REGULAR MEETING OF THE PLANNING COMMISSION

Monday, July 06, 2026

A. West Villages Residences – 315 N Lapeer Street

**Subject: VLO-25-03 West Village (315 N Lapeer Road), Final Site Plan Review
Planning Commission Reconsideration**

WEST VILLAGE RESIDENCE
 EXTERIOR PHOTOMETRIC PLAN
 GASSER BUSH ASSOCIATES
 WWW.GASSERBUSH.COM

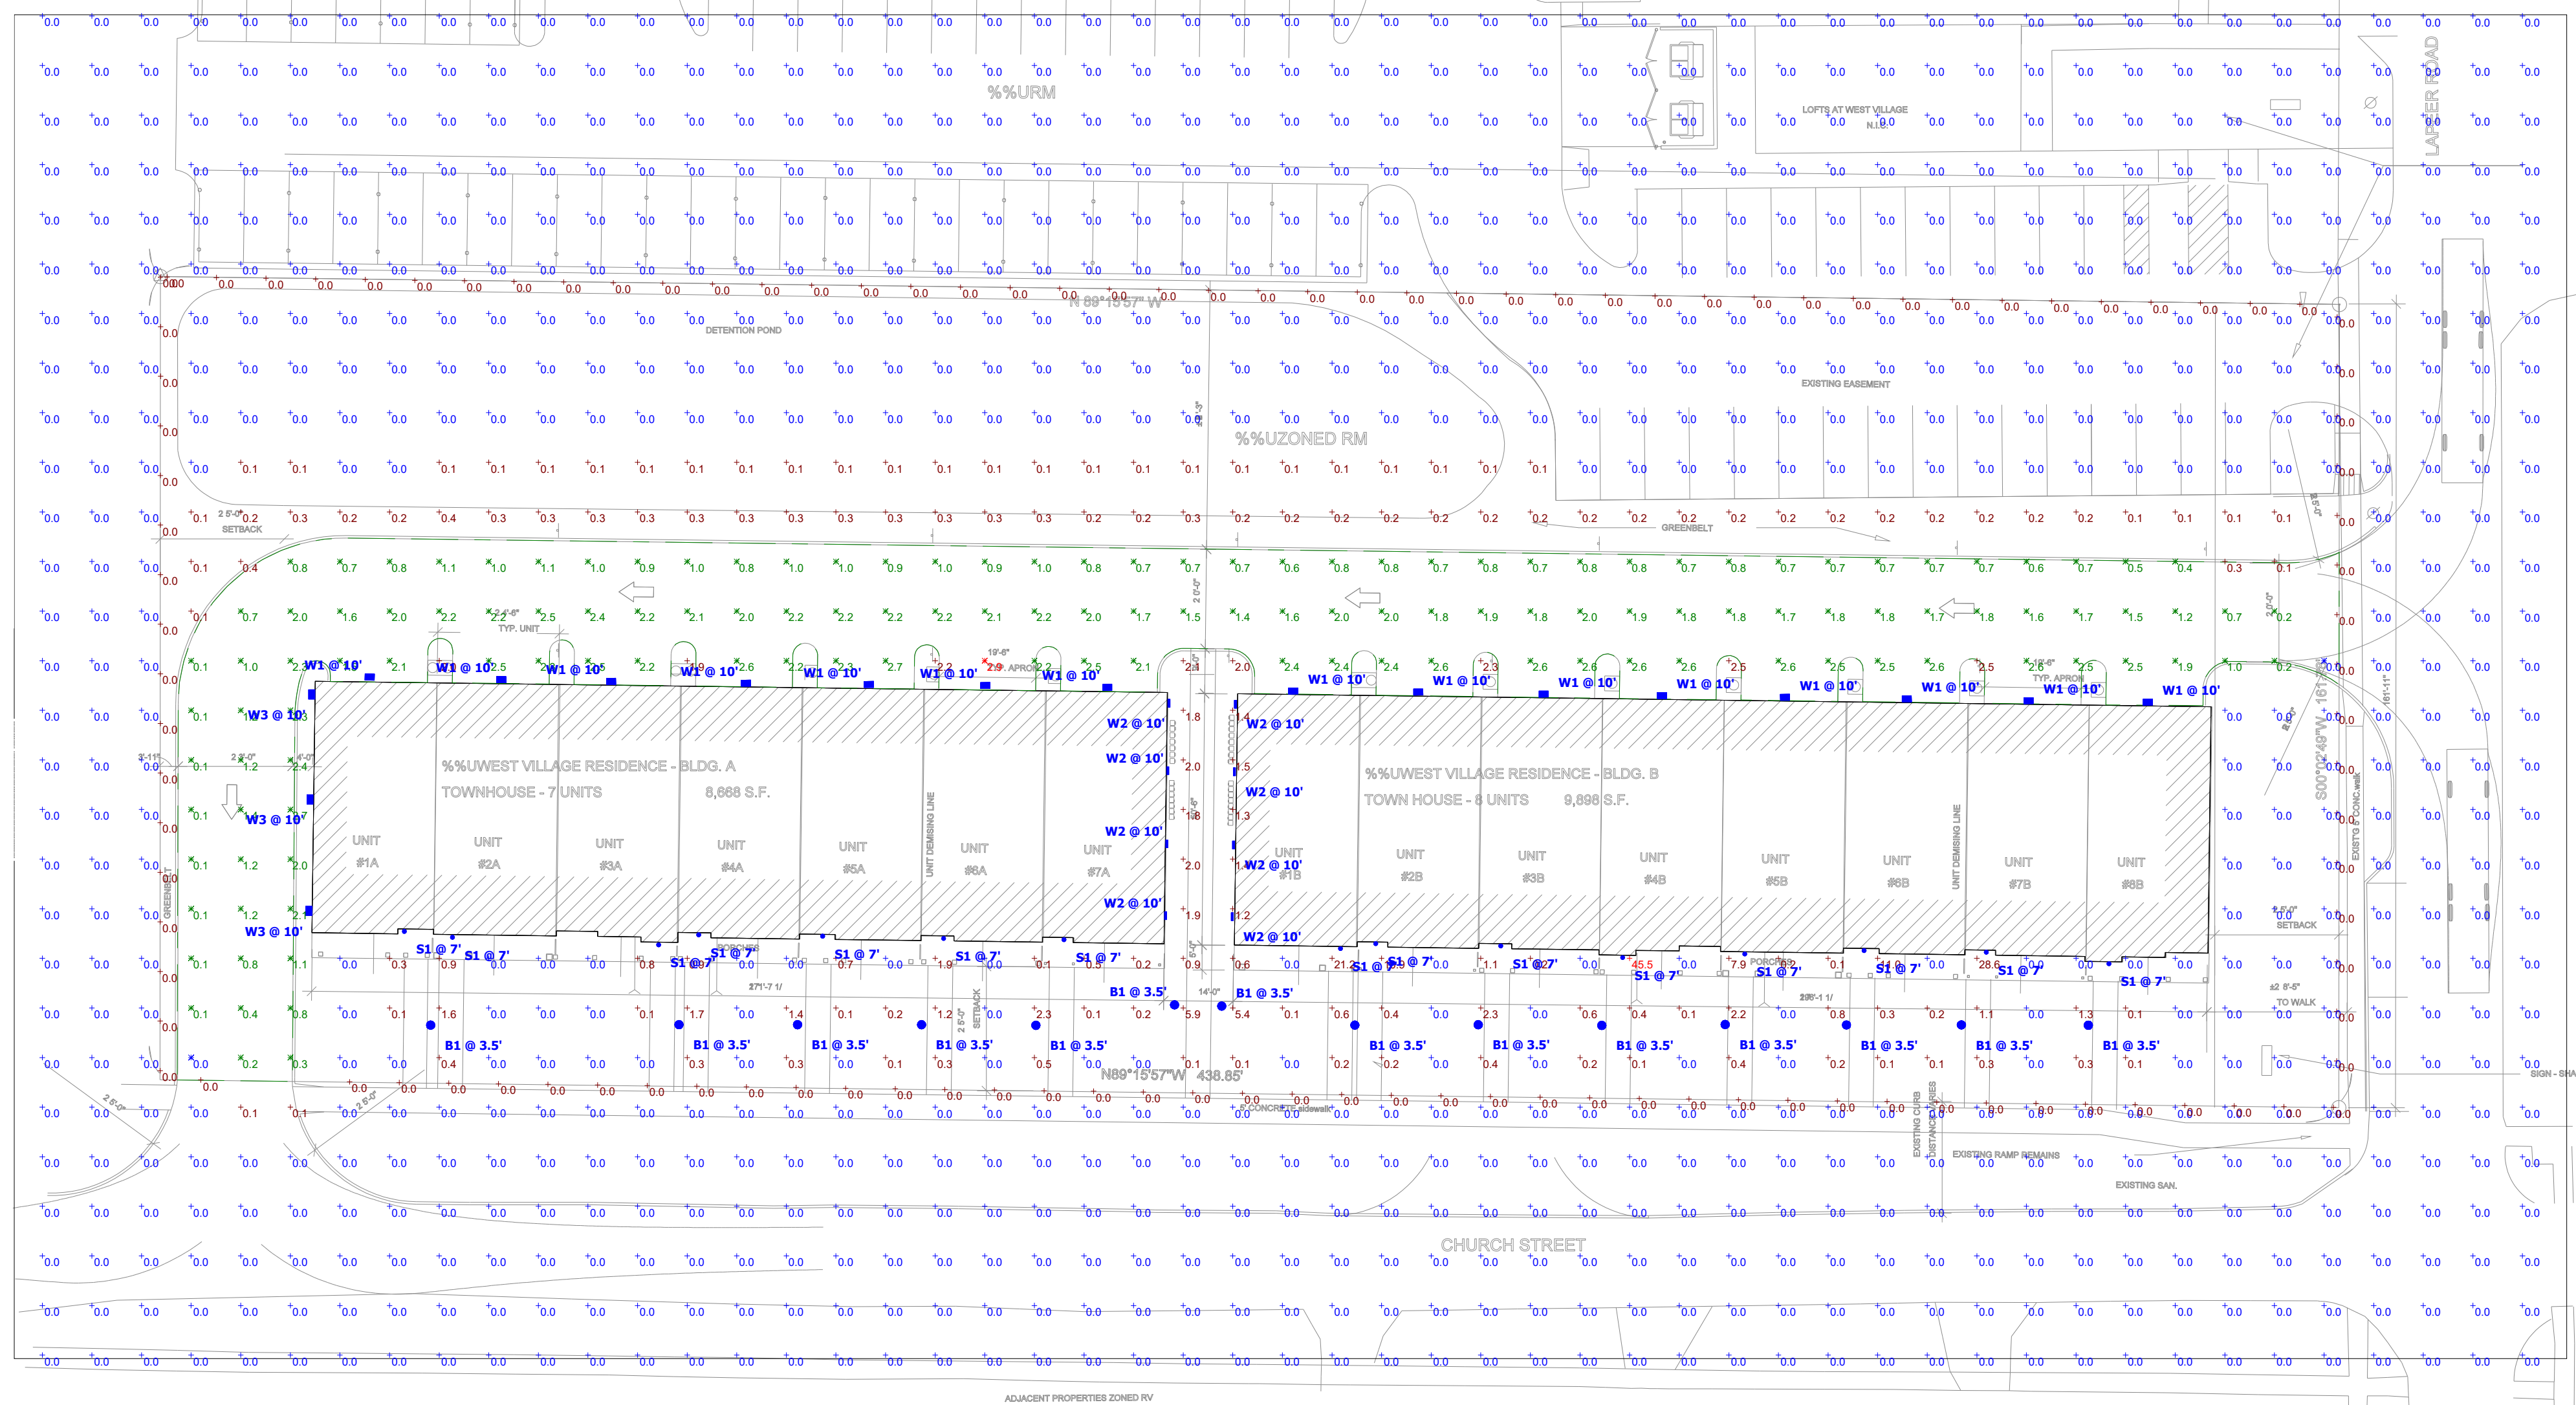
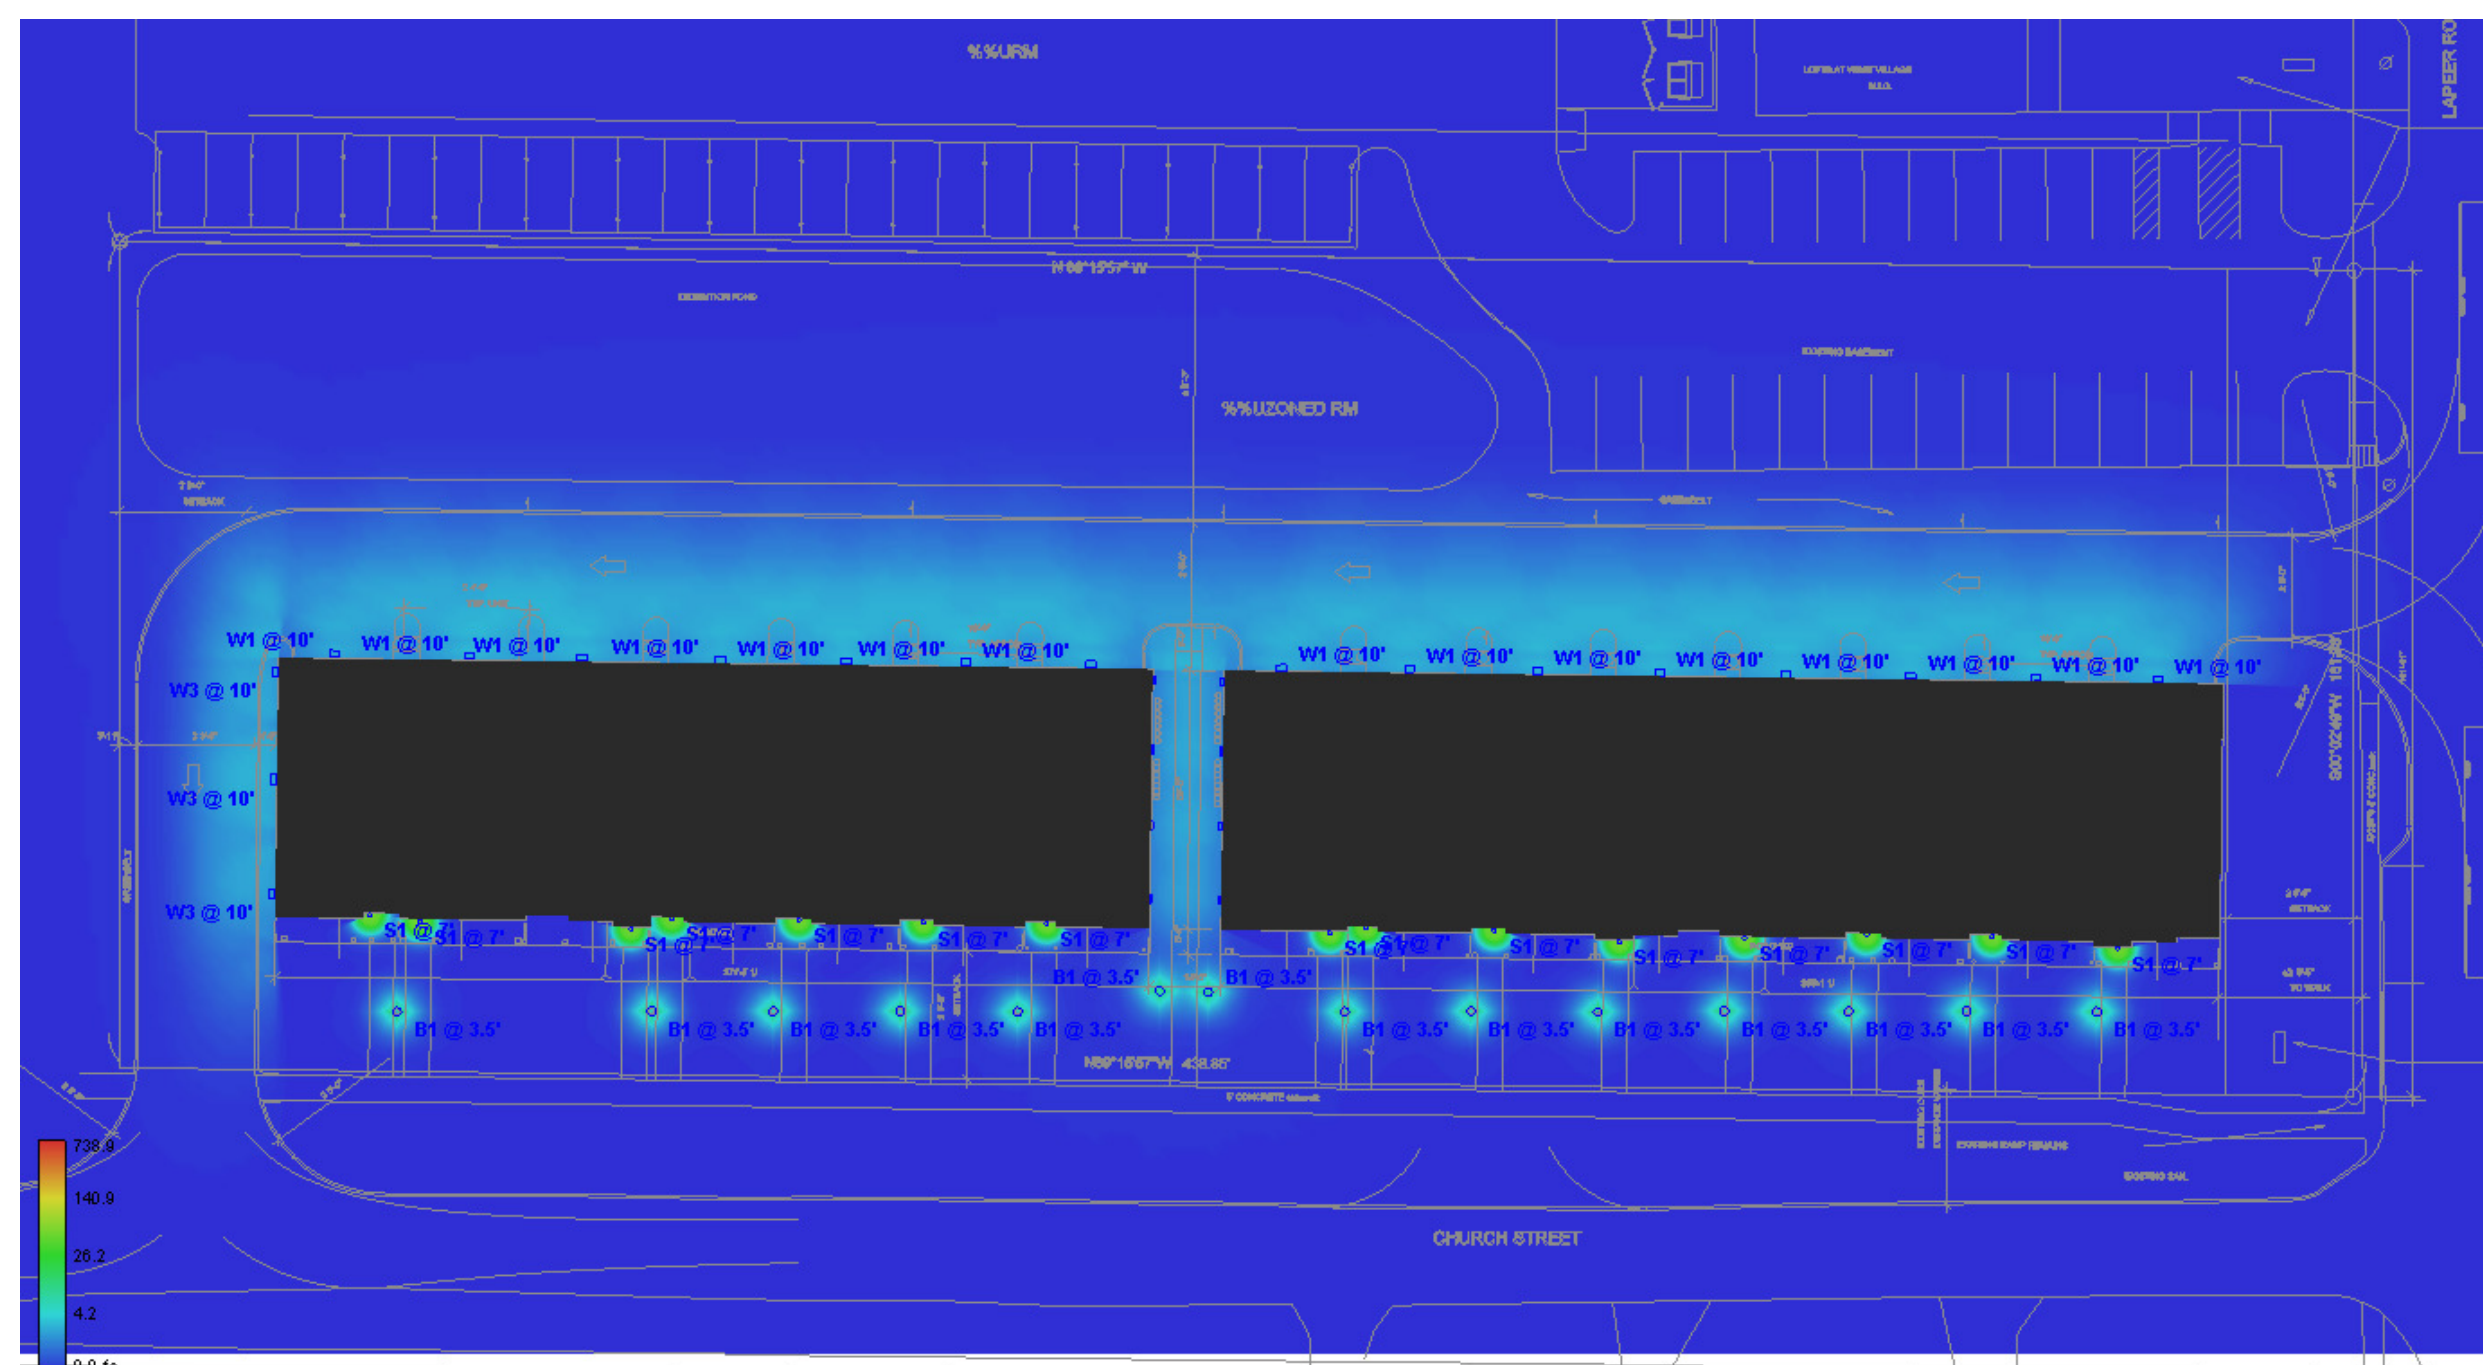
- Addressing the simplest conditional requirement first, we note that the submitted photometric plan indicates a certain amount of light bleeding across the west property line. Light sources must be designed to not impact adjacent properties.
 1. A related issue is noted in our first site plan review, where the existing on-site tree buffer along the property line is being removed, and no replacement screening has been proposed between this site and the dissimilar land use to the west, as required by Zoning Ordinance.

- Acknowledged & updated plan with items shown. Photometrics plans updated.
